No. 4789. AGREEMENT CONCERNING THE ADOPTION OF UNIFORM CONDITIONS OF APPROVAL AND RECIPROCAL RECOGNITION OF APPROVAL FOR MOTOR VEHICLE EQUIPMENT AND PARTS. DONE AT GENEVA, ON 20 MARCH 1958¹

ENTRY INTO FORCE of amendments to Regulation No. 4² ("Uniform provisions for the approval of devices for the illuminating of rear registration plates of motor vehicles (except motor cycles) and their trailers") annexed to the above-mentioned Agreement

The text of the amendments (*Supplement 2 to Regulation No. 4 in its original form*) reads as follows:

Figure 1

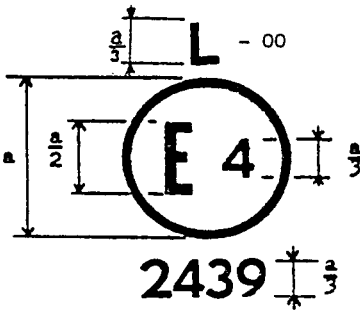
Annex 1, amend to read:

The device bearing the approval mark shown above is a device for the illumination of a vehicle's rear registration plate (L) approved in the Netherlands (E 4) pursuant to Regulation No. 4 under approval number 002439. The approval number indicates that the approval was granted in accordance with the requirements of Regulation No. 4 in its original form or as amended by supplements 1 and/or 2, as the case may be.

Figure 2

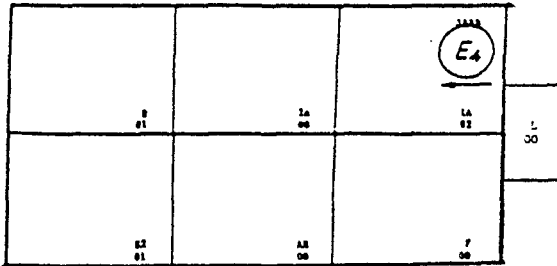
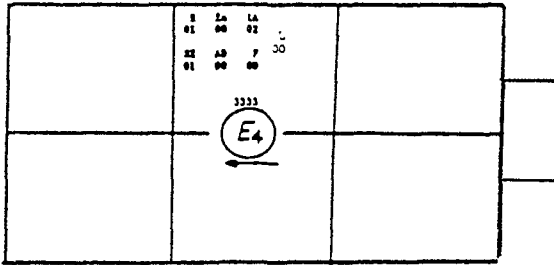
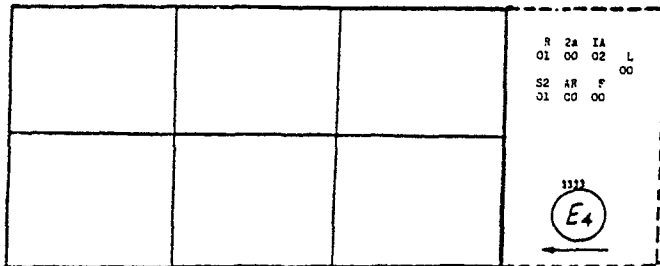
Note: The three examples of approval marks, models B, C and D represent three possible variants of the marking of a lighting device when two or more lamps are part of the same unit of grouped, combined or reciprocally incorporated lamps. This approval mark shows that the device was approved in the Netherlands (E 4) under approval number 3333 and comprising:

Figure 1

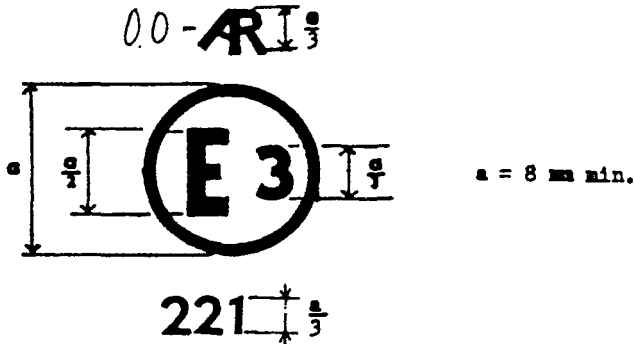
Annex 2, amend to read:

The device bearing the approval mark shown above is a reversing lamp approved in the Netherlands (E 4) pursuant to Regulation No. 23 under approval number 221.

5. MEASURING AND AIMING SCREEN
(dimensions in mm for 25 m distance)

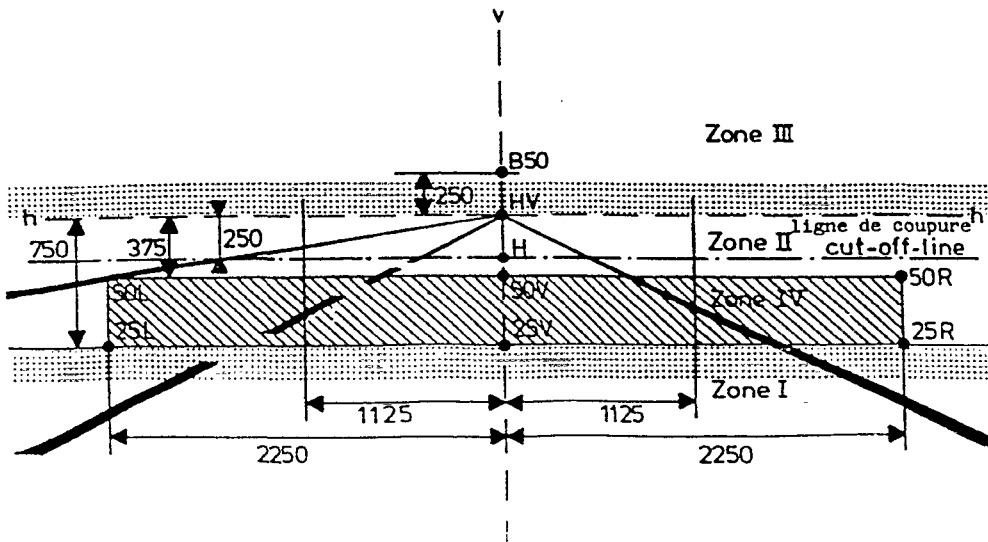
Paragraph 5., replace by the following diagram:
